Review of Professor Kenneth Torrance report regarding the Boundary Road Landfill Site Project, Ottawa

June 8th 2016

Jacques Locat, Ph.D.,
Department of Geology and Geological engineering,
Université Laval,
Québec, Qc

Figure 1. Modified geotechnical profile found in Appendix H, Figure H1 providing the actual data on the liquidity index and specific lines for values of 1.2 and 1.65.

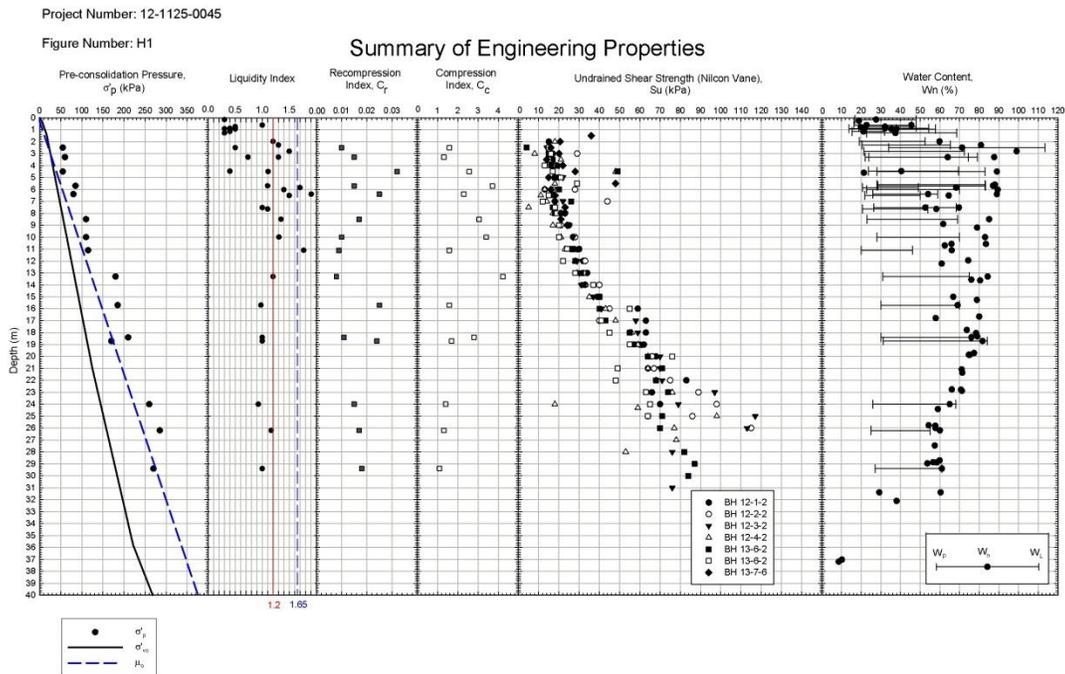
Prof. Torrance uses a liquidity index of 1.2 when referring to the presence of sensitive clays and quick clays (p. 7). This value may come from what is used in Québec, but for another purpose. The liquidity index of more than 1.2 is used in Québec, in addition to other parameters such as the slope height, for classifying sensitive clayey soils which, if a landslide is initiated, can transform and retrogress into flow slides (Demers et al. 2014). I consider that the use, by Prof. Torrance, of a liquidity index of 1.2 to define quick clays, is inappropriate. Lowering the liquidity index threshold, as done by Prof. Torrance, results in an increase in the thickness of the quick clay layer as can be noted by inspection of Figure 1.

If the Norwegian criteria of 1.65 were considered, using the liquidity index values calculated from the data provided by Golder (provided on Figure H1 in Volume III Appendix H and modified as Figure 1), only 3 samples would meet this criteria and the thickness of clay classified as quick would be about 6 m. A thickness of less than two metres would meet this criteria if we use the Swedish criteria at a liquidity index of more than 1.75. If we use the Canadian Engineering Foundation Manual and look at the sensitivity (St) profile in Appendix E of the Golder Volume III report, only one point with a sensitivity of more than 16 would meet this criteria suggesting a quick layer thickness less than 2 m.

Opinion #4: I am of the opinion that comment #9 made by Prof. Torrance does not provide any precision on the actual thickness of the “quick clay” layer at the Boundary Road site, nor does it provide the definition he would use himself to locate it along the profile. I am also of the opinion that a liquidity index value of 1.2 is not appropriate here. If known and accepted definitions for quick clay from elsewhere are used, then the thickness of the quick clay layer reduces significantly from about 11 m (using 1.2) to about 6 m (for a LI of >1.65) and to less than 2 m when using $St > 16$ or a LI of >1.75 .

Figure 3. Estimation of changes in void ratio and water content at the end of primary consolidation for a sample located at a depth of 13.3 m.

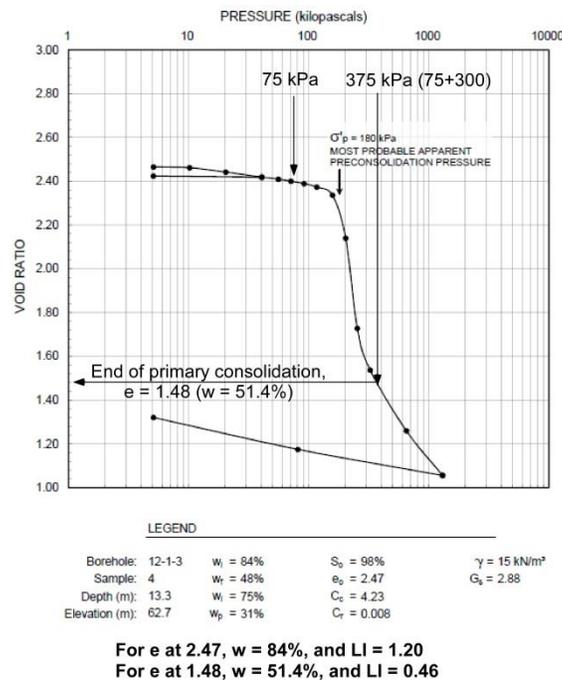
A simple computation of the expected changes in the liquidity index of the soft sensitive clay due to the reduction of the water content (the liquid and plastic limits remaining constant) resulting from the consolidation under the landfill weight is shown in Figure 3. For that example, the oedometer test presenting a high compressibility of 4.2 is used. That sample has been taken at a depth of 13.3 m and in the natural pre-development condition is under an estimated effective stress of 75 kPa. At the end of construction of the landfill, the maximum increase in effective stress is estimated at about 300 kPa (Volume III, p. 73), which means that the stresses at 13.3 m would become about 375 kPa. If we use the oedometer test result obtained for that sample, i.e., a relationship between pressure and “e” the void ratio (or water content), we can see that the void ratio at the end of the primary consolidation could be about 1.48, which is equivalent to a water content of 51.4%. Replacing the value of the initial water content of 84% (corresponding to an initial void ratio of 2.47) by the value of 51.4% at the end of primary consolidation, the new value of the liquidity index decreases significantly from 1.20 to 0.46, i.e., well below the liquid limit of 75%. If a similar calculation is performed for a clay sample from 6.4 m (Figure F19, Appendix F of Volume III) that is within the upper zone where the clay is softer (and more compressible) and the LI is higher, the water content would reduce from 89% to 47% and the LI from 1.9 to 0.62, again well below the liquid limit.

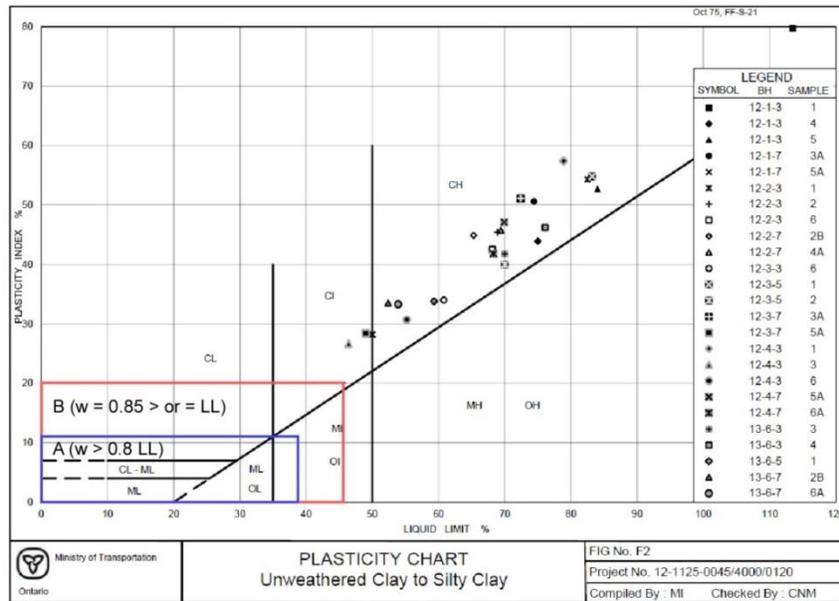
Opinion #9: The Leda clays at the landfill site are not liquefiable in the 'classic' definition. Further, the local topography and environmental setting at the site (rather flat) do not provide the conditions for flow slides to develop.
